MILPITAS PLANNING COMMISSION AGENDA REPORT

TITLE: TIME EXTENTION NO. TE2007-4

Proposal: A request for a one time 18-month time extension for previously approved station upgrades, minor site modifications, and signage for Union 76 Gas Station.

Location: 97 S. Abbott Avenue (APN: 022-28-018)

9 POLE / MONUMENT SIGN
N.T.S.

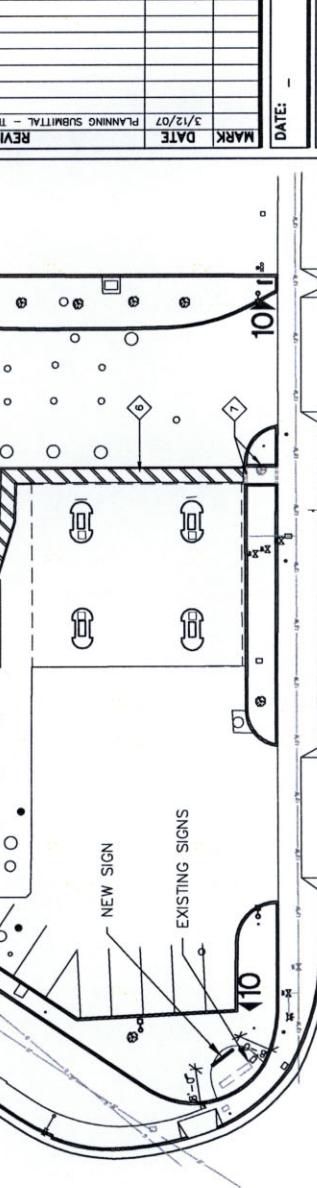
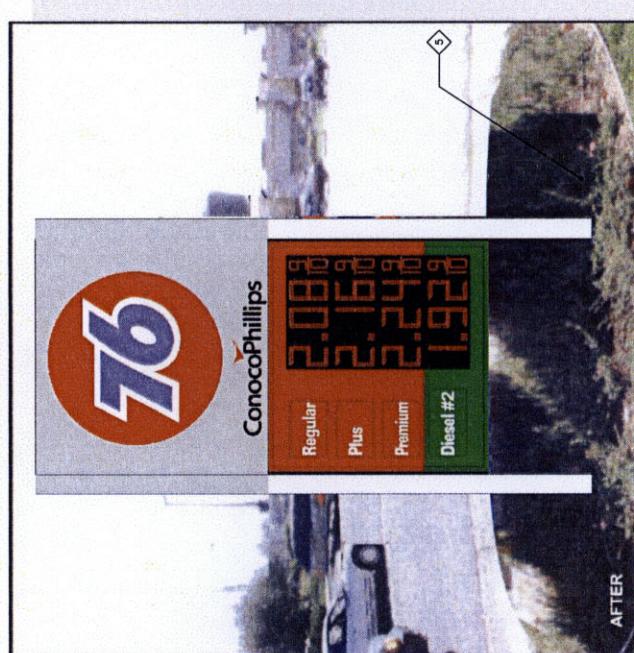
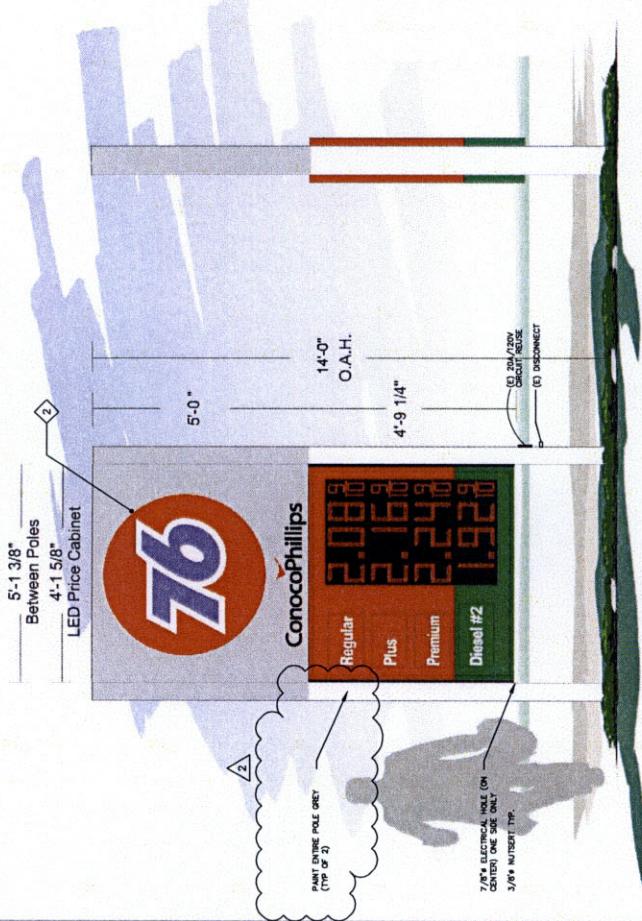
9. The applicant shall obtain an encroachment permit from City of Milpitas Engineering Division for installation of the freestanding signs (sign location 9 and 10 on sheet A3). There are existing facilities nearby (street light box and clean out) in the area. The construction plans shall include a note for the contractor to locate existing facilities to avoid conflict with signs. One foot of separation is required between the sign foundation and existing facilities. The freestanding sign at the corner (location 9) shall be located 8' (not 5' as shown on sheet A3) from the property line.
